PLANNING CLEARANCE
 (Single Family Residential and Accessory Structures)
Community Development Department

BLDG ADDRESS 2449 Perona Ct ~~2945-072-32-001~~ SQ. FT. OF PROPOSED BLDGS/ADDITION Approx 1530 Sq Ft

(1) TELEPHONE _____ DESCRIPTION OF WORK & INTENDED USE Detached Garage

Memo to file

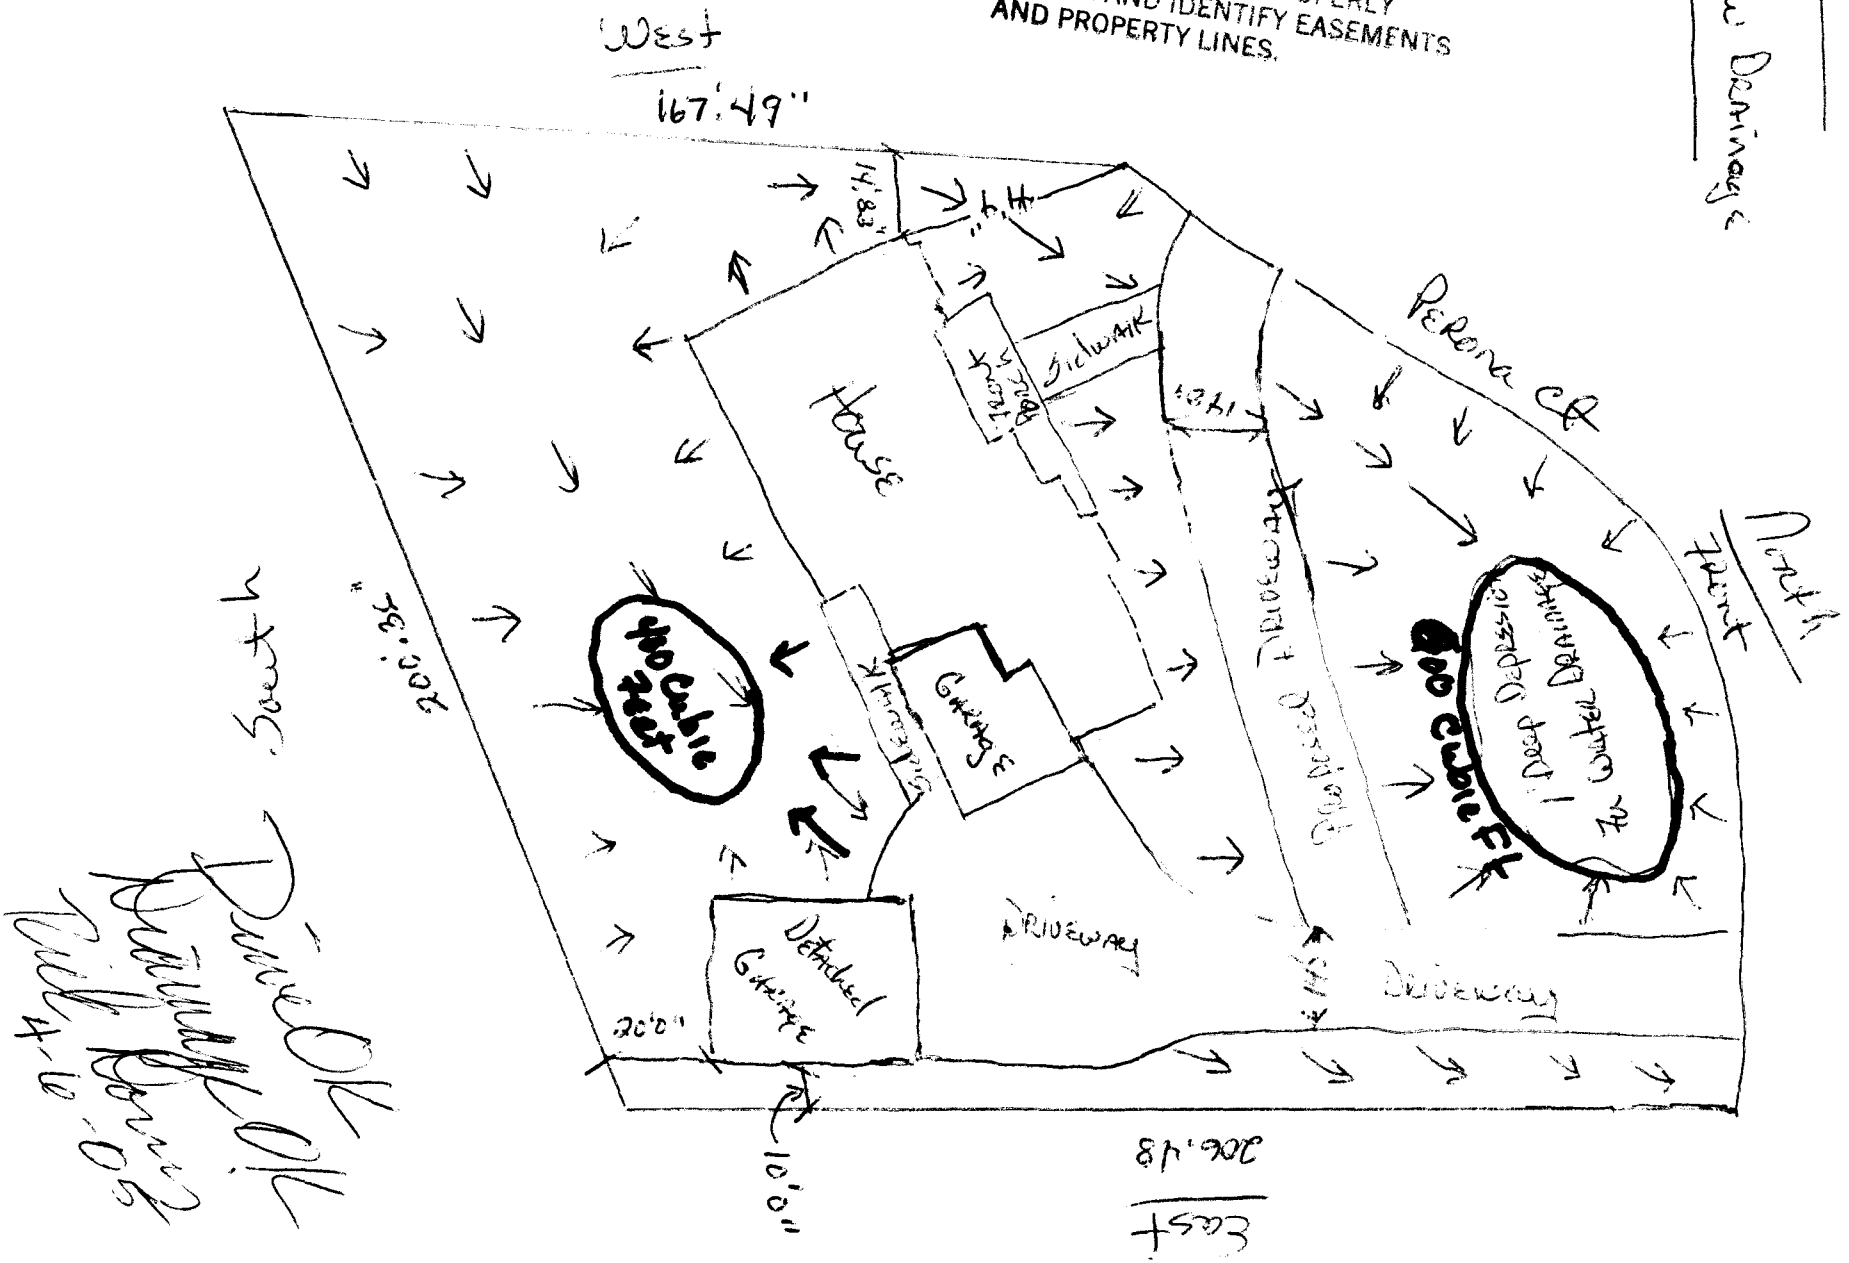
Addresses show Drainage

Revised & Updated

South
200'35"
Drainage OK
Drainage OK
Full 4-10-05
